Response to Review RC1 by Referee #1.

The authors present spaceborne (CALIOP) lidar observations of cirrus clouds and compare the measurements performed at midlatitudes and high latitudes. This is a good contribution to cirrus research at mid to high northern latitudes. However, several parameters are not well defined. The discussion of the results needs to be improved. Uncertainty ranges need to be given.

Figure R1. The dependence of PLDR on latitudes (25th, 50th = median, 75th percentiles of the datasets representing the entire datasets). The results in different seasons are shown in the different panels. The

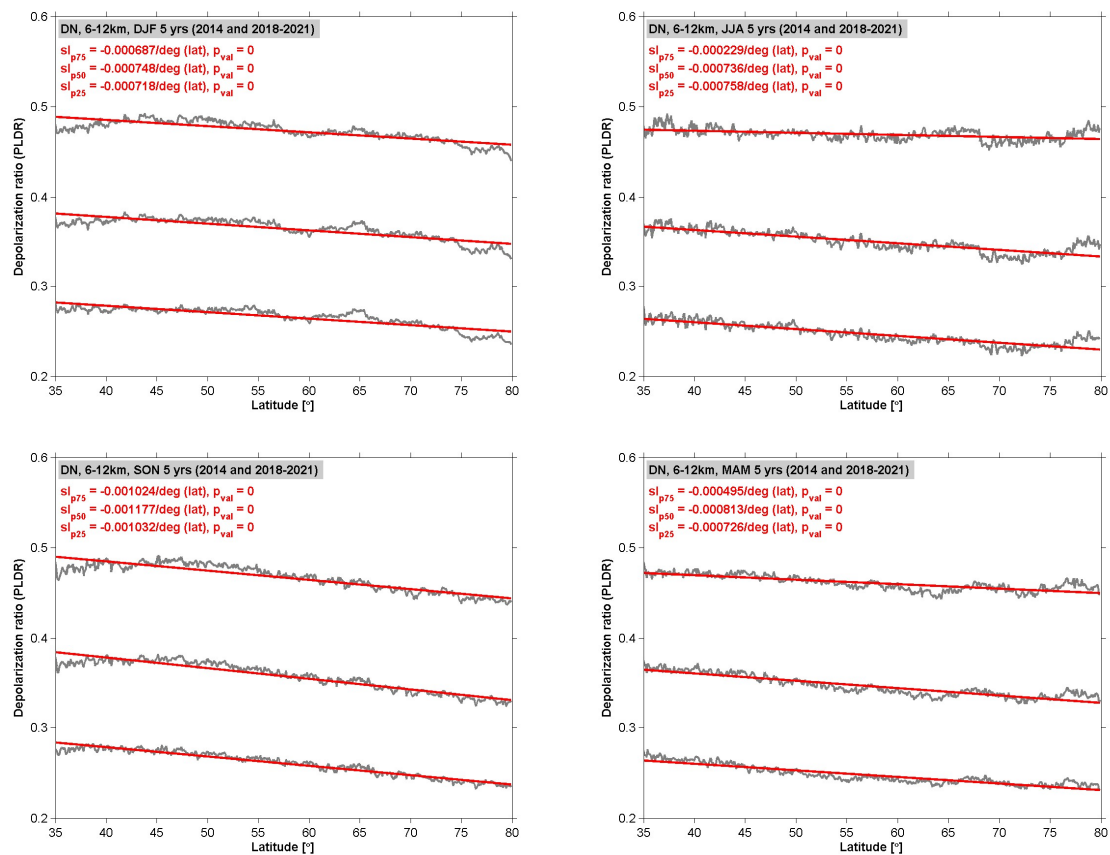
P10: In Fig.6 (and S6-S8), I do not see a clear change of the particle depolarization ratio with latitude, only a weak tendency. The variability indicated by the size of the boxes and bars is so large that a clear dependence is not obtained.

➔ A significance test is added. Based on the Mann-Kendall (MK) significance test, there are clear decreasing trends in the medians as well as 25th percentiles and 75th percentiles of PLDR along latitudes from 35 to 80 degree with the p-values much smaller than 0.001. The exercises have been done to the values in different seasons from different years as well as from all 5 years combined. That means there is a clear change of PLDR with latitude. Only exception is found in the case in Spring (Mar-Apr-May) 2020 when the civil aviation was significantly reduced in Europe (midlatitude) due to the COVID-19 pandemic as well as due to the unusual strong stratospheric polar vortex. It's partially due to the reduction of aviation impact on cirrus PLDR, which has been reported in our publication (Li and Groß, 2021). See the following figures for the results of significance test for the combined 5 years of data in different seasons.

Figure R2. The cloud subtypes derived from the VFM products (Left panel); The derived PLDR of cirrus clouds with the distribution of them in the inset.

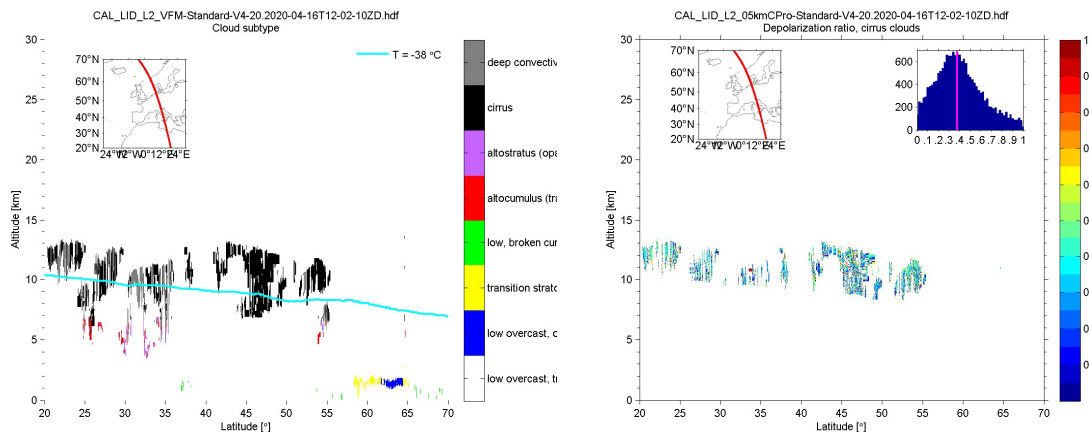
P14: Conclusions should be compact and short. Again you write: Cloud formation shows a clear decrease with latitudes. Maybe!, but you observed cirrus features from the top to the virga bottom. The height distribution of cirrus formation cannot be derived from CALIOP cirrus observations.

- ➔ Conclusions are revised accordingly.
- ➔ I don't agree with the point that the measurements of cirrus features are from the top to the virga bottom. It is described in the manuscript that the data at temperatures above -38°C and with PLDR smaller than 0.1 or larger than 0.8 have been removed (see the plots below).
